UNITED STATES PATENT AND TRADEMARK OFFICE

APPLICATION NO.	FILING DATE	FIRST NAMED INVENTOR	ATTORNEY DOCKET NO.	CONFIRMATION NO.
10/688,877	10/21/2003	Mizuki Murata	2257-0236P	9350

Office Action Summary

DETAILED ACTION

Figure 1

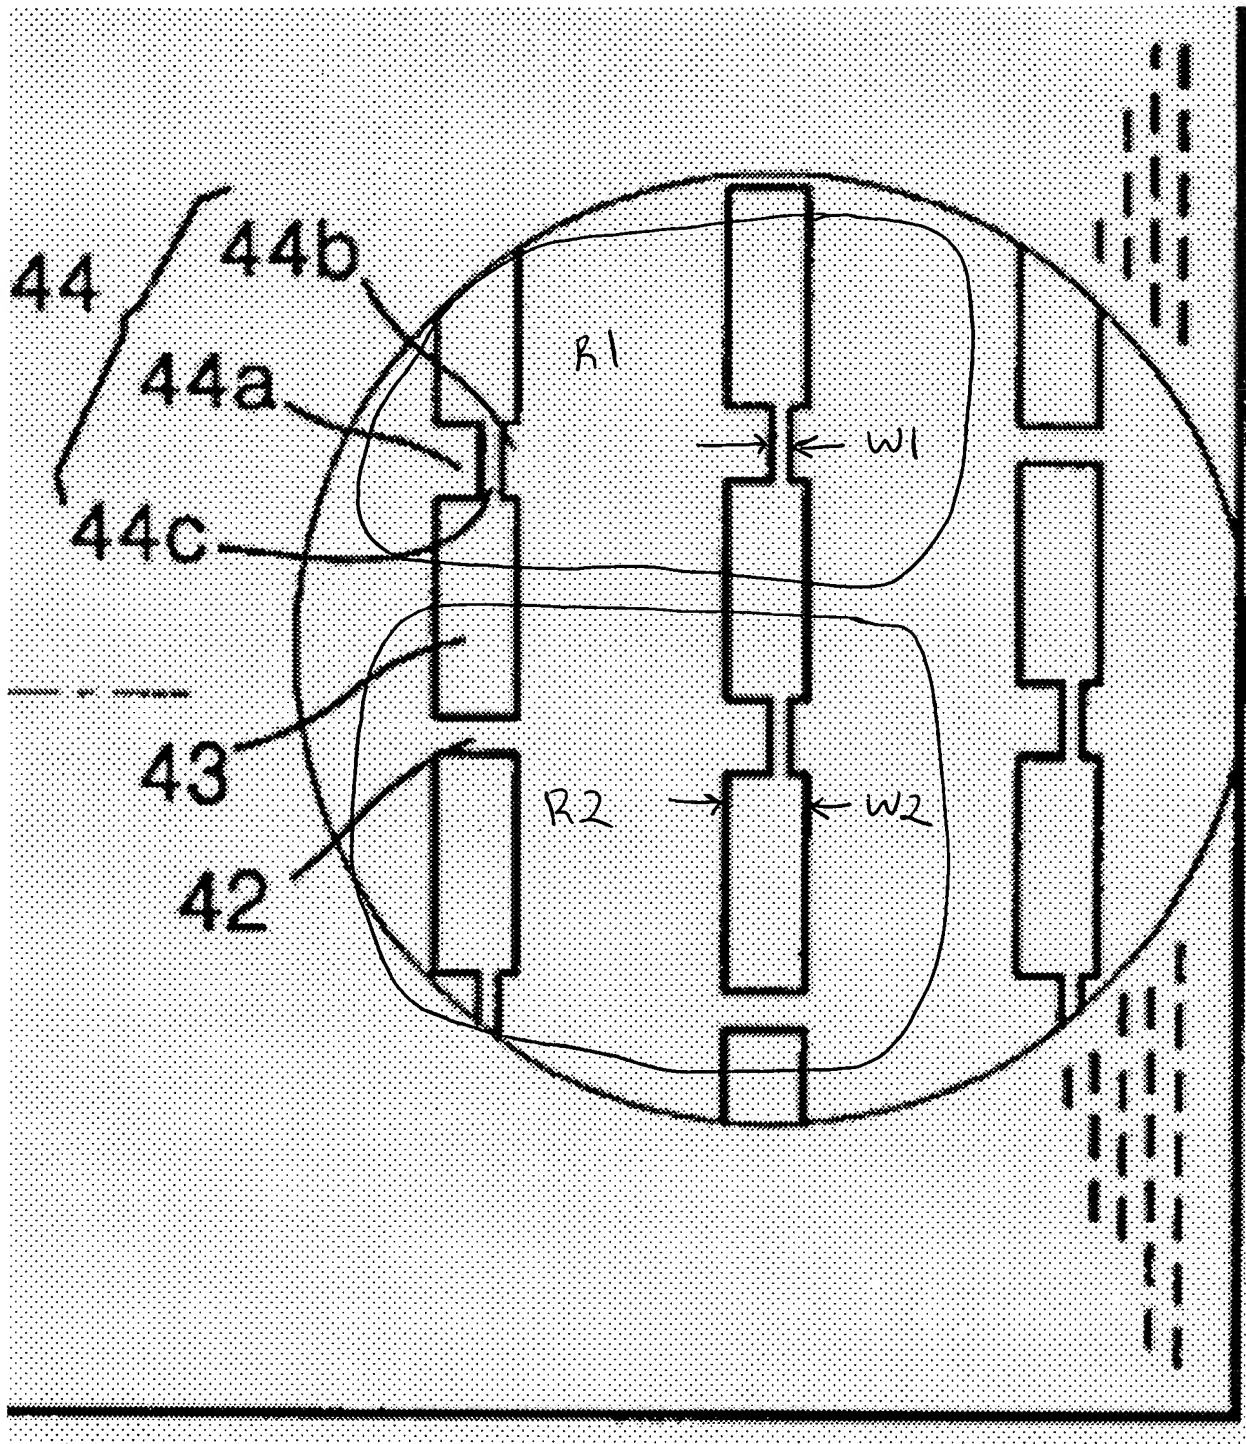
4. Claims 1 and 3 are rejected under 35 U.S.C. 102(e) as being anticipated by Shin (US 6,614,154).
5. Regarding independent claim 1, Figures 6 and 7 of Shin '154 show a shadow mask for a color cathode ray tube comprising a plurality of strips (41); real bridges (42) for connecting the strips adjacent to each other; and dummy bridges (44a, 44b) formed in cantilevered fashion on a side part of the strips, wherein a region in which only the dummy bridges are present among the dummy bridges and the real bridges is defined as a first region, and a mixed region having the dummy bridges and the real bridges is

defined as a second region, and wherein the size of the dummy bridges (44a) in the first region is greater than the size of the dummy bridges (44b) in the second region.

7. Thus, Figure 1 illustrates a reproduced portion of Fig. 7 of Shin '154 showing a first region R1 in which only the dummy bridges are present and a second mixed region R2 having both the dummy bridges and the real bridges.

8. Regarding independent claim 3, Figures 6 and 7 of Shin '154 shows a shadow mask for a color cathode ray tube comprising a plurality of strips (41) and real bridges (42) connecting the strips adjacent to each other, wherein a striped mask region devoid of the real bridges is defined as a first region, and a region having the real bridges is defined as a second region, and wherein a slit opening width in the first region is less than a slit opening width in the second region. Also, see Examiner's discussion (§ 6) for the term "region" cited earlier in this office action.

9. Figure 1 also shows the first region R1 devoid of real bridges and the second region R2 having the real bridges. The figure also shows a slit opening width W1 in the first region being less than a slit opening width W2 in the second region.

Figure 2

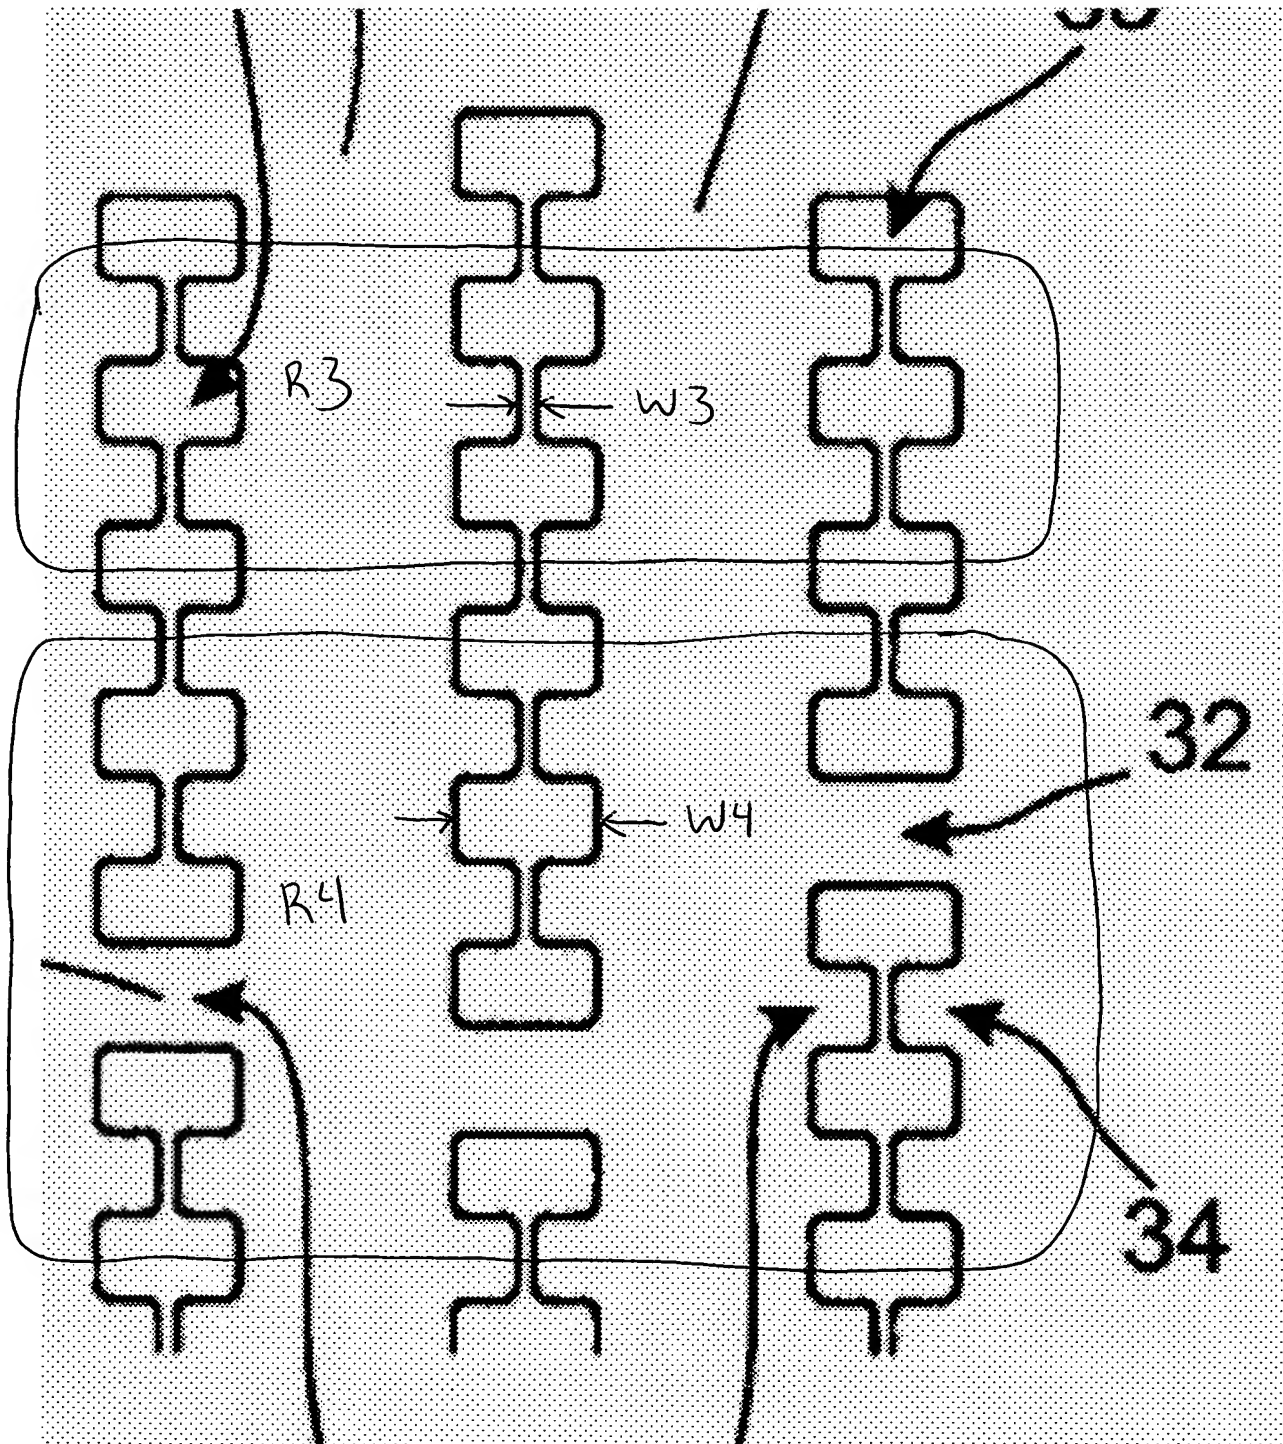
11. Regarding independent claim 3, Figure 4 of Shin '775 shows a shadow mask for a color cathode ray tube comprising a plurality of strips (31) and real bridges (32) connecting the strips adjacent to each other, wherein a striped mask region devoid of the real bridges is defined as a first region, and a region having the real bridges is defined as a second region, and wherein a slit opening width in the first region is less than a slit opening width in the second region.

12. Figure 2 illustrates a portion of Fig. 4 of Shin '775 showing the first region R3 devoid of real bridges and the second region R4 having the real bridges. The figure also shows a slit opening width W3 in the first region being less than a slit opening width W4 in the second region.

17. Figure 2 illustrates a reproduced portion of Fig. 4 of Shin '775 showing a first region R1 in which only the dummy bridges are present and a second mixed region R2 having both the dummy bridges and the real bridges.
